2018 Basin Boundary Modifications - Final

Basin(s): 1-004 SHASTA VALLEY

Requesting Agency: Siskiyou County Flood Control and Water Conservation District

DWR Final Decision: Approve

Basin(s): 1-055.01 SANTA ROSA VALLEY – SANTA ROSA PLAIN; 1-059 WILSON GROVE FORMATION HIGHLANDS

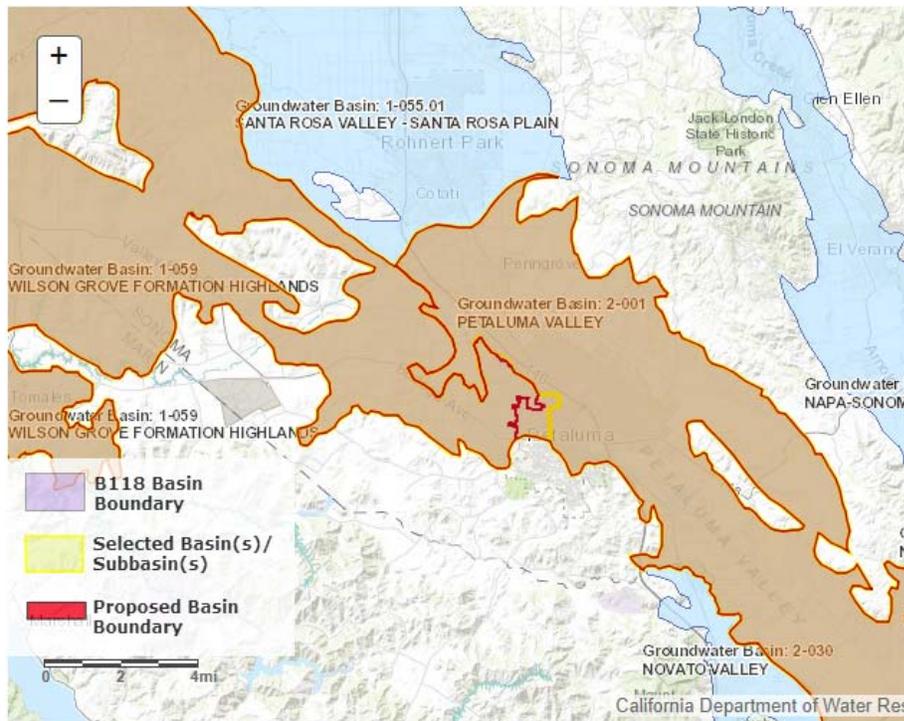
Agency Description:
Modify the Santa Rosa Plain Sub-basin to incorporate the jurisdictional areas of the City of Sebastopol, Belmont Terrace MWC, Fircrest MWC, and Kelly MWC that are currently in the Wilson Grove Formation Highlands Basin.

Basis for Decision: The basin boundary modification request would revise a portion of the existing shared boundary between the Santa Rosa Plain subbasin and the Wilson Grove Formation Highlands basin. The request would modify a portion of the western boundary of the Santa Rosa Plain subbasin such that the City of Sebastopol, Belmont Terrace Mutual Water Company (MWC), Fircrest MWC, and Kelly MWC would be entirely within the Santa Rosa Plain subbasin. Six letters of support are associated with this request. The request meets regulatory requirements.

Basin(s): 1-059 WILSON GROVE FORMATION HIGHLANDS; 2-027 SAND POINT AREA

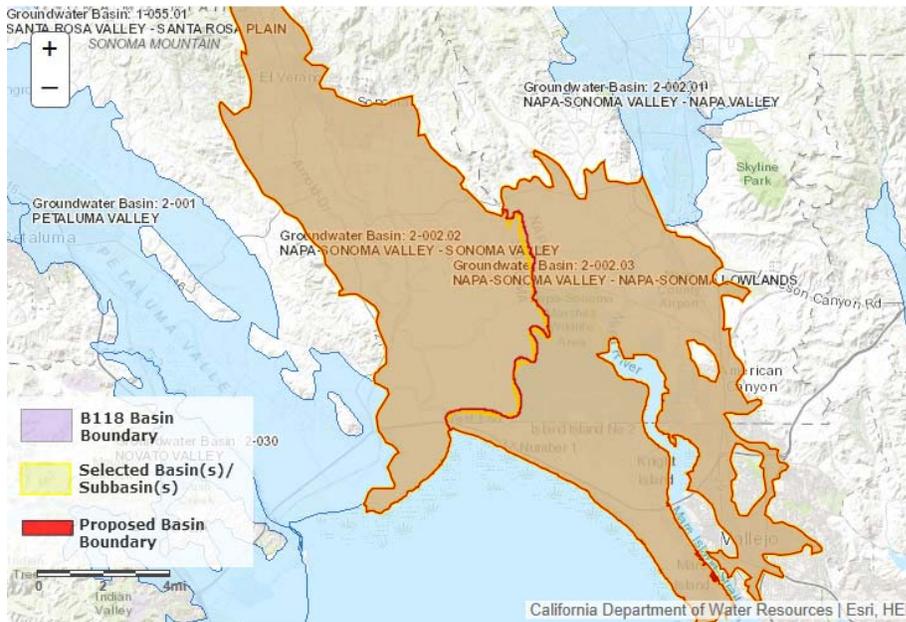
Agency Description:
Internal boundary modification that would extend the Sand Point Area Basin to include the portion of the Wilson Grove Formation Highlands Basin currently in Marin County. The new boundary would be the county line.

Basis for Decision: The basin boundary modification request would move the existing shared boundary between Sand Point Area basin and Wilson Grove Formation Highlands basin to align with the Marin County line. Six letters of support are associated with the request. This request meets regulatory requirements.

Basin(s): 2-002.02 NAPA-SONOMA VALLEY - SONOMA VALLEY; 2-002.03 NAPA-SONOMA VALLEY - NAPA-SONOMA LOWLANDS

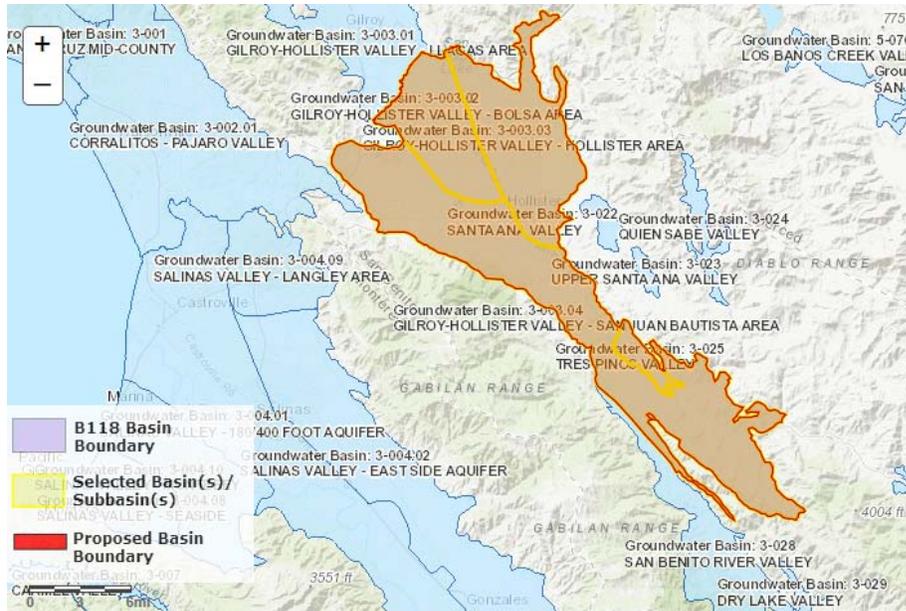
Agency Description: Modify subbasins to align with County boundaries.

Basis for Decision: The basin boundary modification revises and aligns the shared boundary between Sonoma Valley and Sonoma Lowlands to follow the shared Sonoma and Napa County line. Four letters of support are associated with the request. The request meets regulatory requirements.

Basin(s): 3-003-.02 GILROY-HOLLISTER VALLEY – BOLSA AREA; 3-003-.03 GILROY-HOLLISTER VALLEY – HOLLISTER AREA; 3-003-.04 GILROY-HOLLISTER VALLEY – SAN JUAN BAUTISTA AREA; 3-025 TRES PINOS VALLEY

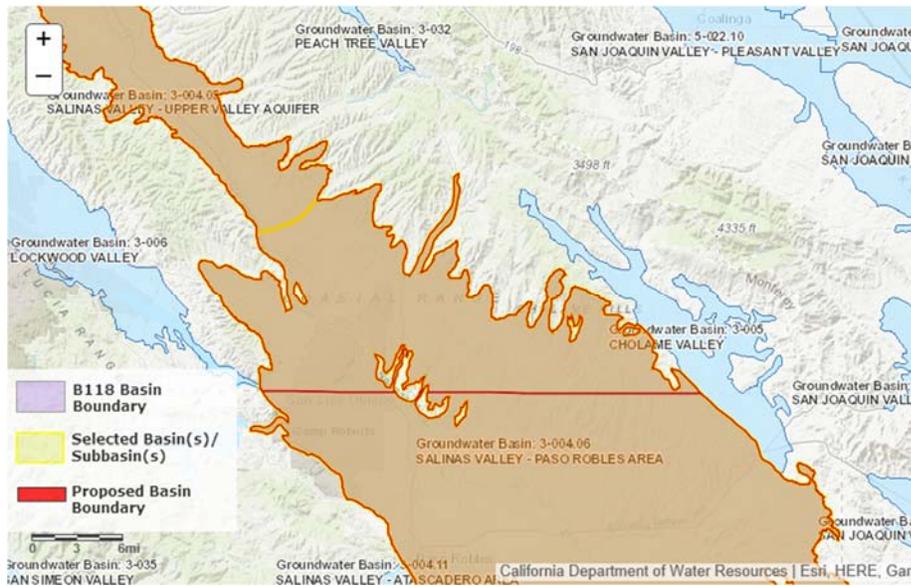
Agency Description: Consolidation of San Juan Bautista, Bolsa, Hollister, and Tres Pinos Valley basins

Basis for Decision: The basin boundary modification would consolidate the Bolsa Area, Hollister Area, and San Juan Bautista Area subbasins of Gilroy-Hollister Valley basin, and the Tres Pinos Valley basin, into a single subbasin. The new subbasin would be named the North San Benito Groundwater subbasin. No revisions are proposed to the resulting external boundary of the subbasin. San Benito County Water District is the exclusive Groundwater Sustainability Agency for all four basins. Nine letters of support are associated with the request. The request meets regulatory requirements.

Basin(s): 3-004.05 SALINAS VALLEY – UPPER VALLEY AQUIFER; 3-004.06 SALINAS VALLEY – PASO ROBLES AREA

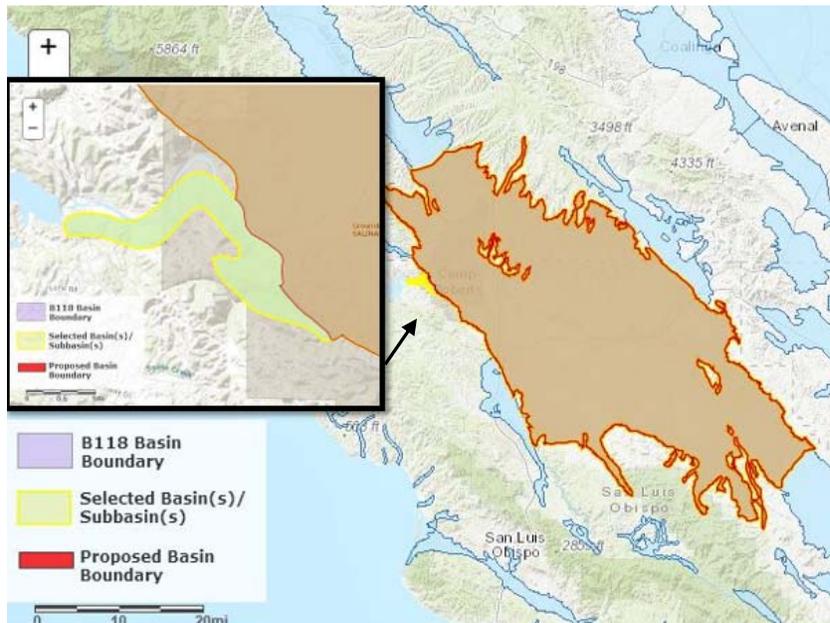
Agency Description: A jurisdictional modification of the Upper Valley Aquifer and Salinas Valley Paso Robles Area subbasins.

Basis for Decision: The basin boundary modification extends the existing shared boundary of the Upper Valley Aquifer and Paso Robles Area subbasins to coincide with the Monterey and San Luis Obispo county line. The request would place the Monterey County portions of the Paso Robles Area subbasin entirely within Monterey County. The resulting boundary between these subbasins would be consistent with existing County and Groundwater Sustainability Agency jurisdictions. Several letters of support are associated with the request. The request meets regulatory requirements.

Basin(s): 4-004.02 SANTA CLARA RIVER VALLEY - OXNARD; 4-004.03 SANTA CLARA RIVER VALLEY - MOUND; 4-004.04 SANTA CLARA RIVER VALLEY - SANTA PAULA

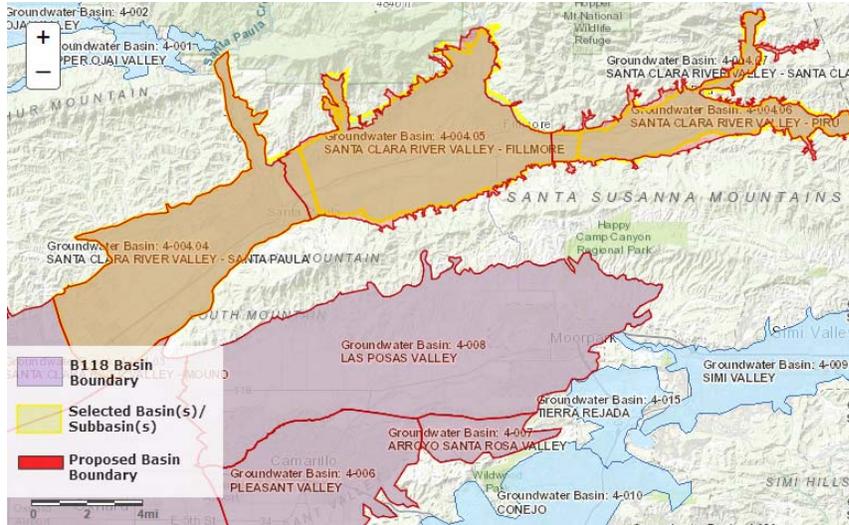
Agency Description: Four proposed modifications: three jurisdictional internal and one scientific external.

Basis for Decision: The basin boundary modification revises and aligns the shared boundary between the Mound and Santa Paula subbasins to align with the Santa Paula adjudicated boundary. The modification also revises the shared boundary between the Oxnard, Mound, and Santa Paula subbasins to align with the Fox Canyon Groundwater Management Agency's boundary and the Santa Paula adjudication boundary, where applicable. The scientific modification along the northern boundary of the Mound subbasin follows mapped alluvial units using a more detailed, 1:24,000 scale, qualified map. Two letters of support are associated with the request. The requesting agency supplies sufficient information to support the scientific rationale for modification and meets regulatory requirements.

Basin(s): 4-007 ARROYO SANTA ROSA VALLEY

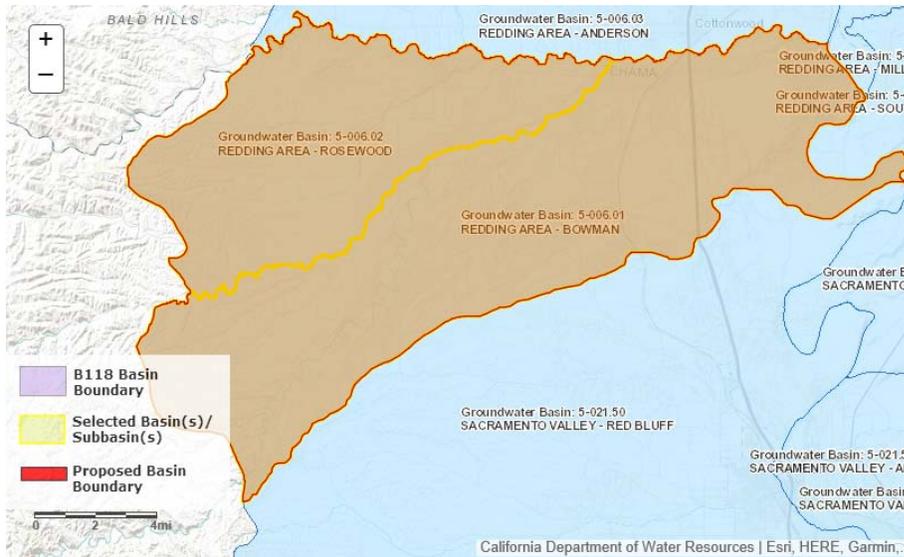
Agency Description: The request would include the extent of alluvium and water-bearing formations in the basin.

Basis for Decision: The basin boundary modification follows geologic contacts on a qualified map. The modification increases the boundary's accuracy by delineating the extent of alluvium on a more detailed scale than previously mapped, and it more accurately incorporates water-bearing formations into the Arroyo Santa Rosa Valley basin. The requesting agency supplies sufficient information to support the scientific rationale for the modification. The request meets regulatory requirements.

Basin(s): 5-006.01 REDDING AREA – BOWMAN; 5-006.02 REDDING AREA – ROSEWOOD

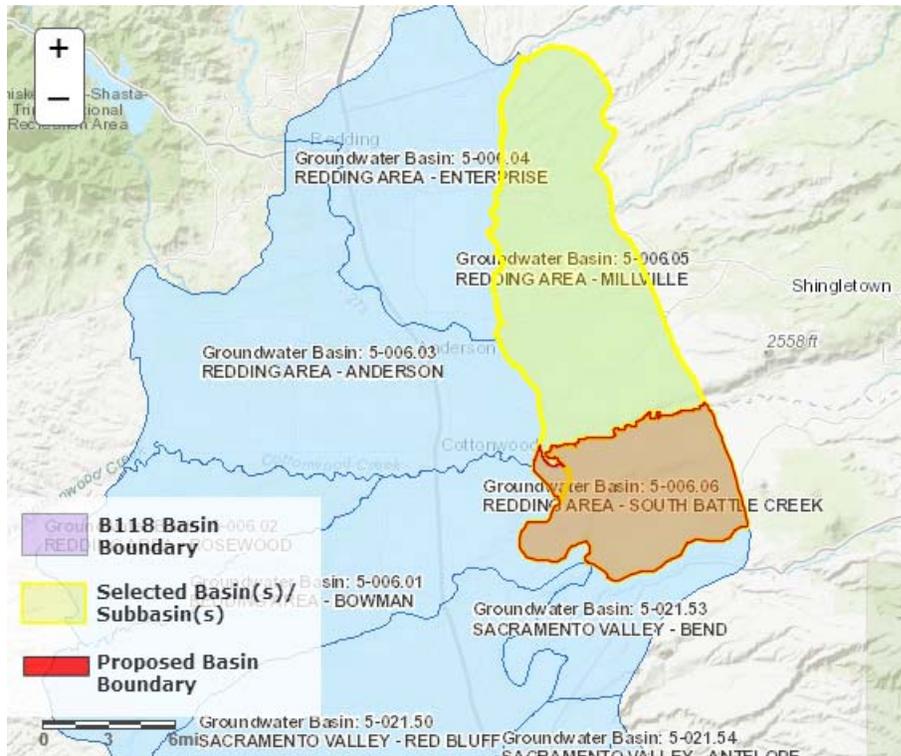
Agency Description: Bowman and Rosewood subbasin consolidation.

Basis for Decision: The basin boundary modification removes the shared boundary between Bowman and Rosewood subbasins and consolidates them into a single subbasin. The requesting agency is the exclusive Groundwater Sustainability Agency in both subbasins. A letter of support is associated with the request. The request meets regulatory requirements.

Basin(s): 5-006.05 REDDING AREA – MILLVILLE; 5-006.06 REDDING AREA – SOUTH BATTLE CREEK

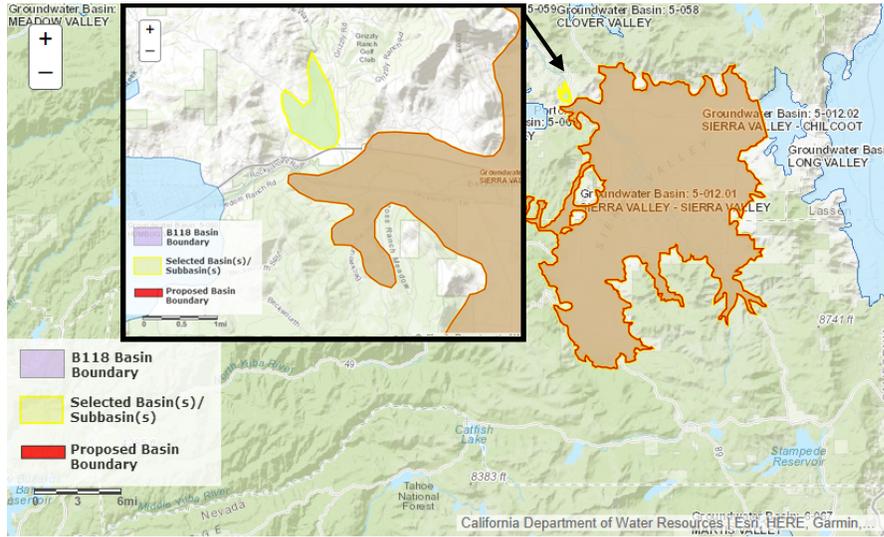
Agency Description: Modification to bring the Tehama County portion of the Millville subbasin into the South Battle Creek subbasin.

Basis for Decision: The basin boundary modification revises the existing shared boundary between the Millville and South Battle Creek subbasins to include the Tehama County portion of the Millville subbasin entirely within the South Battle Creek subbasin. The northern boundary of the South Battle Creek aligns with the shared Tehama and Shasta County line. The request meets regulatory requirements.

Basin(s): 5-012.01 SIERRA VALLEY – SIERRA VALLEY

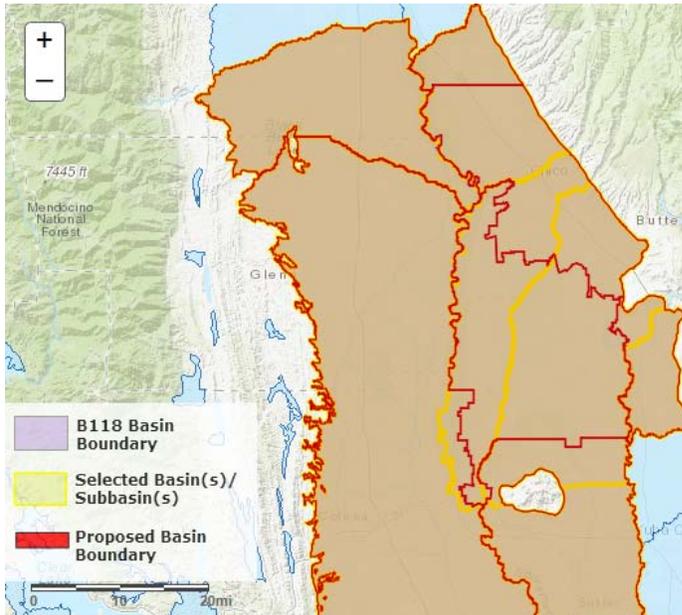
Agency Description:
Plumas County, as one of the GSA's for Sierra Valley Basin, requests a scientific modification to the external basin boundary.

Basis for Decision: The basin boundary modification removes a small mapped alluvial area from the delineation of the Sierra Valley basin. Geologic maps, well completion reports, and technical studies submitted by the requesting agency indicate that the area is not an alluvial basin, nor is it hydrologically connected to the Sierra Valley Basin. One public comment (neutral) was submitted on the draft decision to approve the modification. The request meets regulatory requirements and provides sufficient scientific rationale to support the modification.

Basin(s): 5-021.51 SACRAMENTO VALLEY - CORNING; 5-021.52 SACRAMENTO VALLEY - COLUSA; 5-021.57 SACRAMENTO VALLEY - VINA; 5-021.58 SACRAMENTO VALLEY - WEST BUTTE; 5-021.59 SACRAMENTO VALLEY - EAST BUTTE; 5-021.62 SACRAMENTO VALLEY - SUTTER; 5-021.69 SACRAMENTO VALLEY - WYANDOTTE CREEK

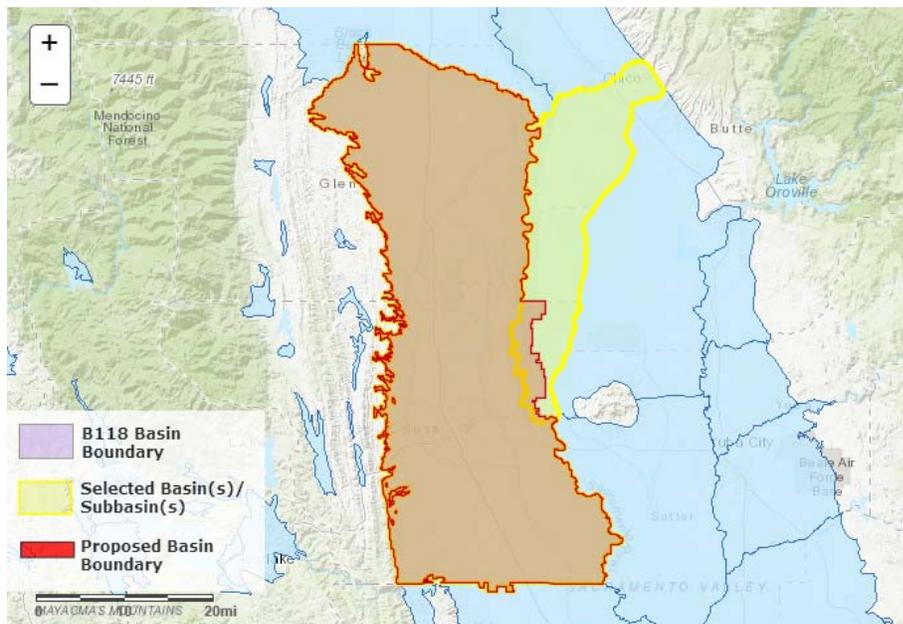
Agency Description: Jurisdictional consolidation to create the Butte basin and modify surrounding subbasins.

Basis for Decision: The basin boundary modification consists of four parts. The first part revises and expands the Vina subbasin to cover groundwater dependent areas currently included in the northern portions of East Butte and West Butte subbasins. The modification extends the Butte County portion of Vina Subbasin southerly to the northern boundary of Western Canal Water District. The resulting Vina subbasin includes the City of Chico, unincorporated Durham, and the Durham Irrigation District. The second part modifies the western boundaries of the existing Butte County portion of Vina, and West Butte subbasins, near the Sacramento River to align with the Butte County line. The third part revises the southern boundary of the East Butte subbasin to follow the Butte/Sutter County line except for the Biggs-West Gridley Water District and Reclamation District 1004 jurisdictional boundaries; which results in these Districts being entirely within the resulting Butte subbasin. The fourth part consolidates the remaining East Butte and West Butte subbasin areas to form the Butte subbasin. Thirteen letters of support are associated with this request as well as the requesting agencies response to public comments. The request satisfies regulatory requirements for each jurisdictional modification.

Basin(s): 5-021.52 SACRAMENTO VALLEY – COLUSA; 5-021.58 SACRAMENTO VALLEY – WEST BUTTE

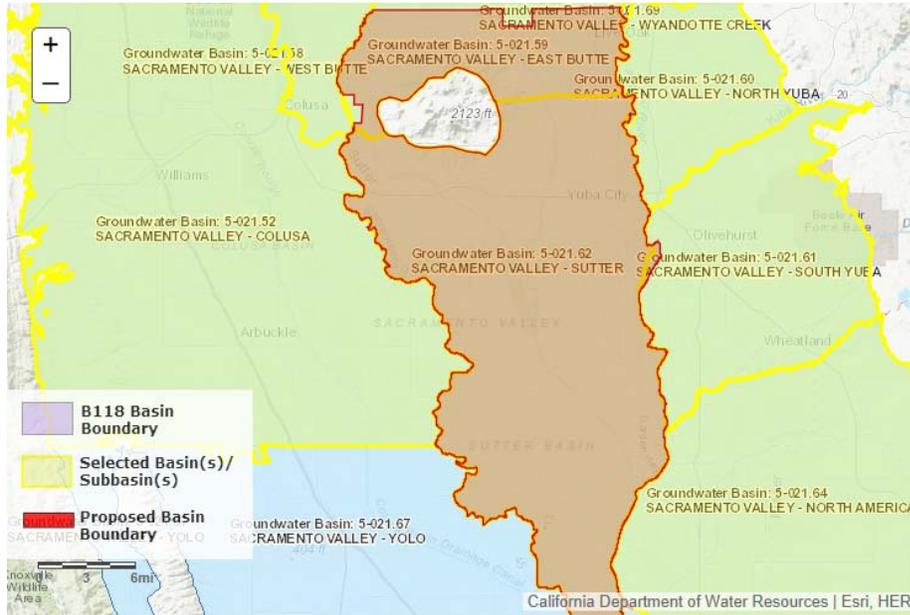
Agency Description: Modification to bring a portion of the West Butte subbasin into the Colusa subbasin.

Basis for Decision: The basin boundary modification revises the central-easterly boundary of the Colusa and West Butte subbasins to extend easterly to follow the western boundary of Reclamation District 1004. The revision places the Colusa Groundwater Authority wholly within the Colusa subbasin. Three letters of support are associated with the request. One public comment was submitted opposing the draft decision to approve the modification. The request meets regulatory requirements.
